Service Bulletin

14-030

Slapping or Clicking From Engine Area at Idle Supersedes 14-030, dated June 18, 2014, to revise the information highlighted in yellow.

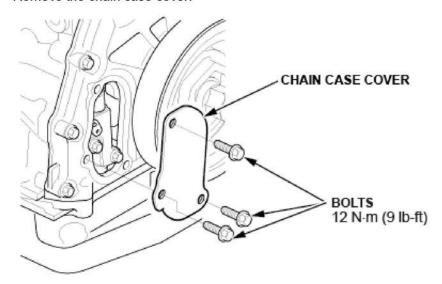
Under REQUIRED MATERIALS, the oil was changed to Full Synthetic Engine Oil, P/N 08798-9063.
